Re: Response to HCDEH Letter dated February 14, 2005

Fortuna Beacon Petro Mart
390 South Fortuna Boulevard, Fortuna, CA
HCDEH LOP No. 12093
Blue Rock Project No. FNC-3

East-West Soil Cross Section

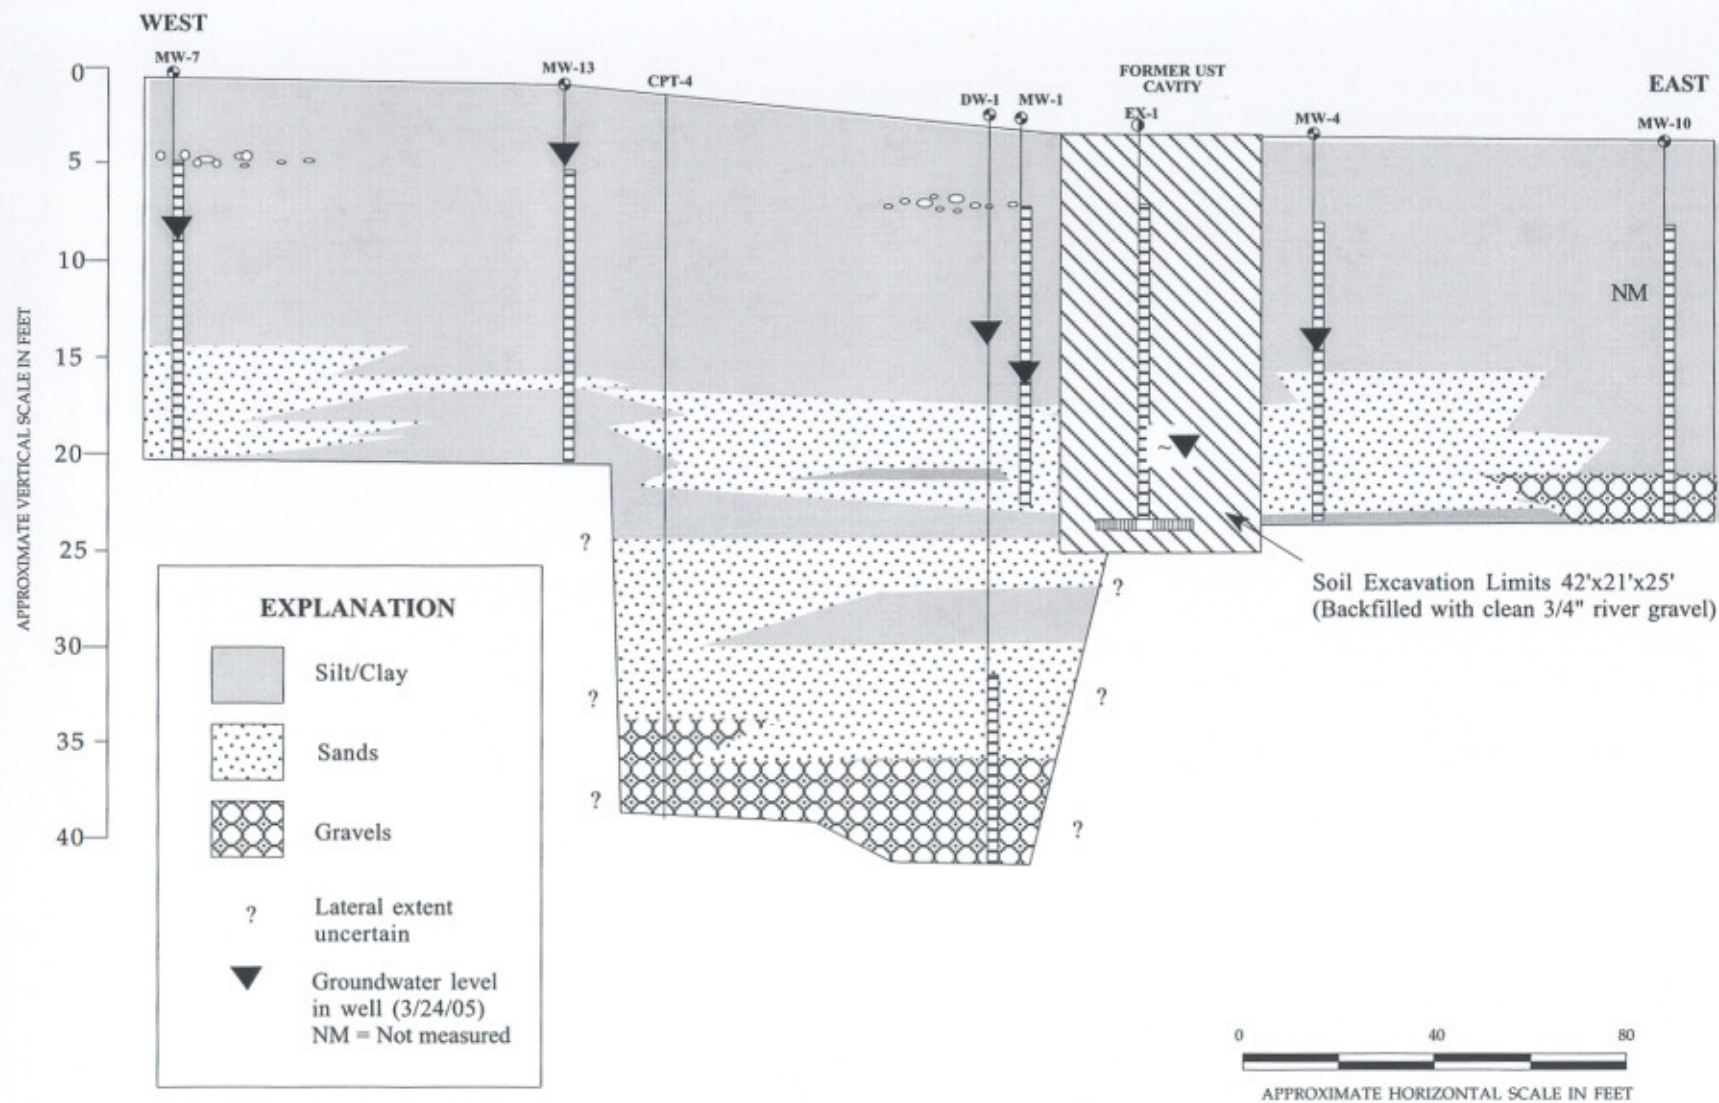
Show depth to water for MW-13 on Figures 6B and 6C. Table One indicates depth to water averages less than four feet. Figures 6B and 6C show water depth at 11 feet. Comment on depth to water observed in MW-2, RW-4B, and MW-13. What conditions are causing this area of shallow groundwater? What data can be used to evaluate your interpretation? Did any previous holes, specifically holes less than 10 feet deep, have water? Were any shallow holes left open for an extended period of time to evaluate the possibility of a shallow, perched water table? Does data from the adjacent site, Cash Oil, provide useful information?

The groundwater levels from the first quarter 2005 monitoring event are shown on Figure 6b and 6c (attached). The shallow water levels observed MW-2, RW-4B, and MW-13 may be the result of localized, perched zone, as past drilling and excavation observations possibly indicate thin, laterally discontinuous zones at depths of approximately 5 feet bgs. These conditions have been specifically observed during previous drilling of wells MW-1, MW-2 and MW-11, as intersecting a seasonal (December through June) shallow water-bearing (perched) zone (~4-8 feet bgs). Additionally, during the drilling of DW-1 through DW-3 in April 1996, soil samples collected at a depth of approximately 5 feet bgs were described as "wet", yet no water collected in the borehole. Also, during drilling of RW-4, the hole was dry to a depth 20 feet. RW-4 was drilled with the intention to collect and remove LNAPL on groundwater; however, no water entered this borehole and it was grouted without construction of a well. It is unknown how long previous borings were left open, and at which depths, to allow water to accumulate.

North-South Soil Cross Section

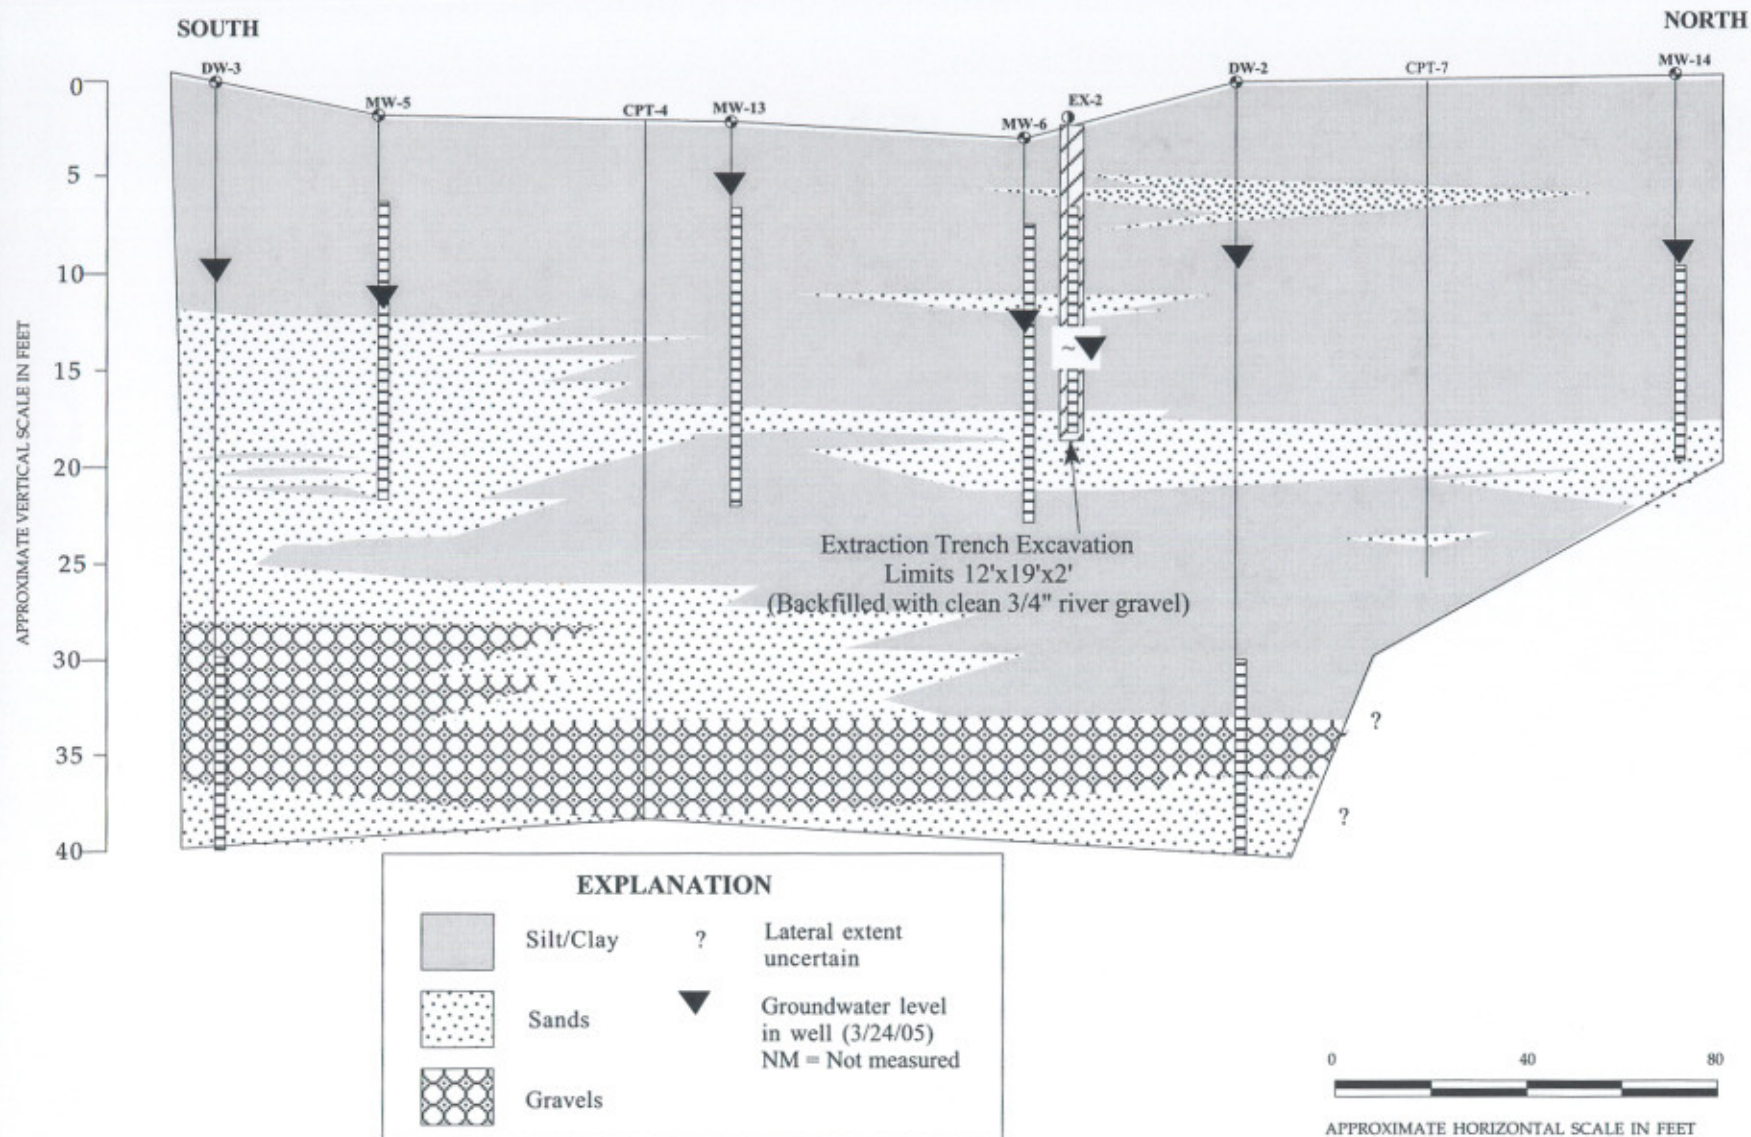
Comment on the drawdown effect of pumping? Is EX-1 pulling water from the deeper zone? Are the shallow and deep zones hydraulically connected? What data did you use to come to your interpretation?

Blue Rock is of the opinion that, although mostly separated by fine-grained soil, the shallow and deep water bearing zones appear to be connected in the area of DW-3, based on logs for DW-3 and cross-section construction (Figure 6c). Because of this apparent sedimentological connection and since EX-1 basin appears to tap into the deep water bearing zone (Figure 6c), Blue Rock believes the groundwater extraction system is affecting the deep water bearing zone. This is supported by the fact that the deep wells show progressive clean-up since start-up of the system.

MW-1 vs DW-1 Groundwater Elevation
Fortuna Beacon Mini mart
390 S. Fortuna Blvd., Fortuna, CA

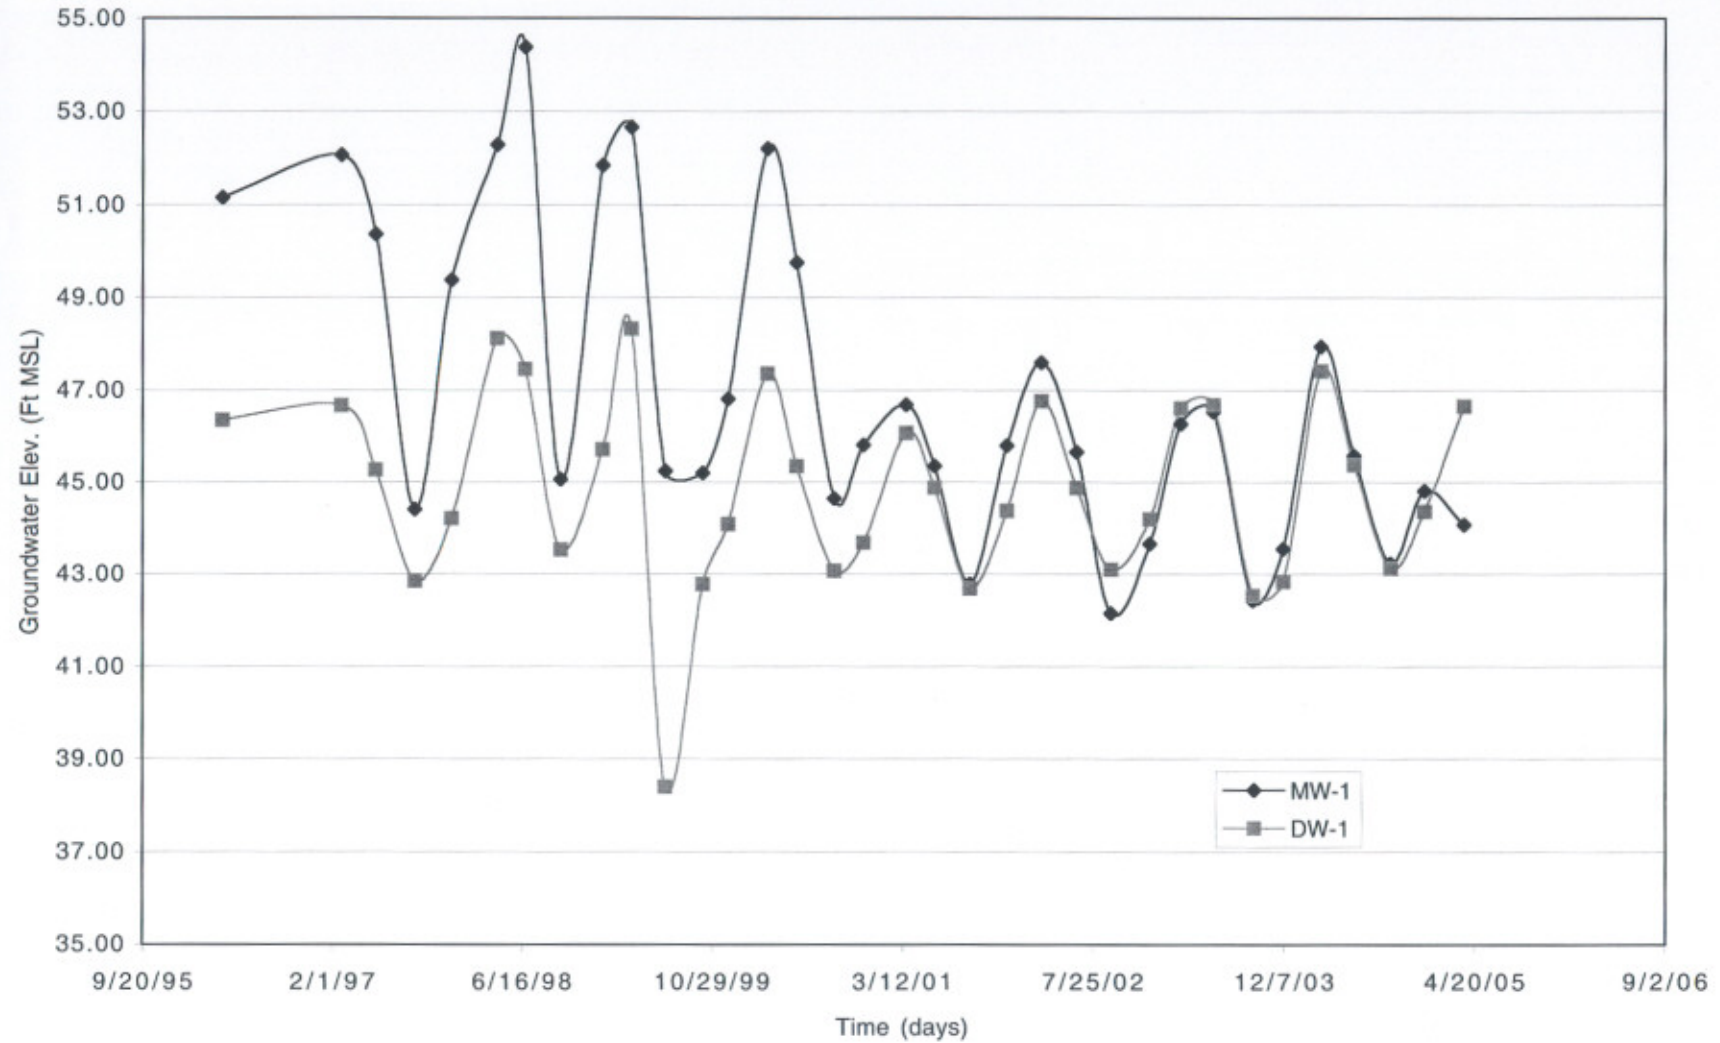
MW-1 and DW-1 are screened from 5-20 and 30-40 feet bgs, respectively, and located five feet from each other. There is a dramatic change in the data beginning in approximately March 2001. Prior to this time, there was an average four-foot difference in the relative elevation of water in MW-1 and DW-1. Since this time, depth to water has differed by an average of 0.3 feet. Please comment on this observation.

Blue Rock plotted groundwater elevations versus time for MW-1 and DW-1. Blue Rock concurs that the difference in groundwater elevation between the two wells diminishes to approximately less than 0.5-feet beginning around March 2001. Before that time, groundwater in MW-1 was typically higher than DW-1 by about three feet on average. The plot shows that groundwater elevations for MW-1 have fallen to the levels of DW-1, while, the groundwater elevations of DW-1 have remained relatively consistent in their seasonal patterns. The remedial excavation and EX-1 installation occurred in August 2001, and the groundwater extraction system started in August 2002. Based on the timeline, groundwater elevations for MW-1 and DW-1 began to coincide about six months before remedial excavation began and about one-a-half years before groundwater extraction began. Although these remedial activities would be the first apparent reason for these groundwater changes, the chronology of events suggests that it is most likely a natural occurrence. Because these two wells are located proximal to each other, it would suggest a downward vertical gradient prior to March 2001 in the area of MW-1/DW-1, and then little to no significant vertical gradient thereafter. It is possible that these conditions may also suggest that the groundwater extraction system is dewatering the shallow zone in the area of MW-1, and/or that the groundwater levels are responding to the installation of EX-1 which appears to tap into both zones (Figure 6b). Although EX-1 may tap into both zones, operation of the system appears to have a beneficial effect on the deep zone wells, as dissolved-phase concentrations have decreased to below NCRWQCB levels in all three deep wells for approximately the last four quarters.
